Product Bulletin #00093

Subject: Support Bracket Change on XSMC Shaft Extensions

Date: August 28, 2020

XSMC with new Clamping Style Bracket

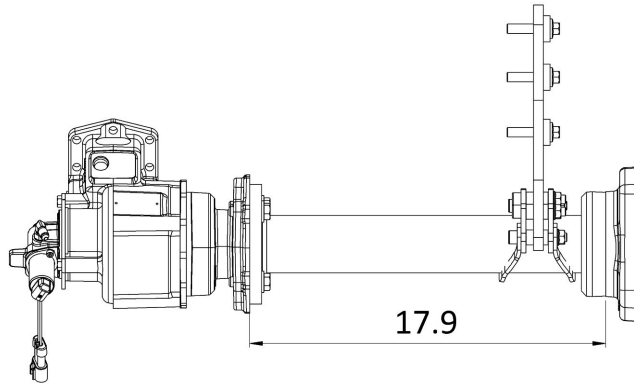
A design change is being implemented on the support brackets on all XSMC shaft extensions. The “J” bracket design is being replaced by a clamping bracket, similar to the bracket used on XS24 and XD10 shaft extensions. This is an inline change, and as such will not result in a new model code for the shaft extensions.

The new bracket features two clamps that squeeze against the shaft extension housing, providing a very rigid installation. The installation of the new bracket is very similar to the old style bracket, with the exception of clamps on the bottom.

"J" Bracket (Old)

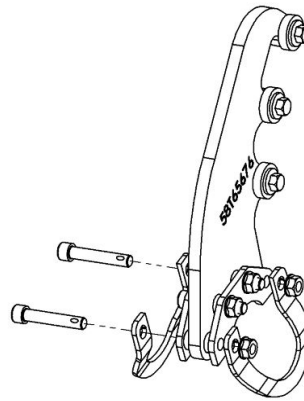
Most existing installations currently using the old “J” bracket can be converted to the new clamp style bracket, with the exception of XSMC-A40XX-X3**XX units. This is due to length of the housing on those units, which are too short to accommodate the clamping mechanism on the new bracket. Units of XSMC-A40XX-X3**XX

built on or after 9/7/2020 will feature a longer housing, and will be shipped with the clamping style bracket. The new housing will measure 17.9" from PTO mounting face to output flange mounting face. The old housing will measure 17.0" at the same place. All other housings will remain unchanged.
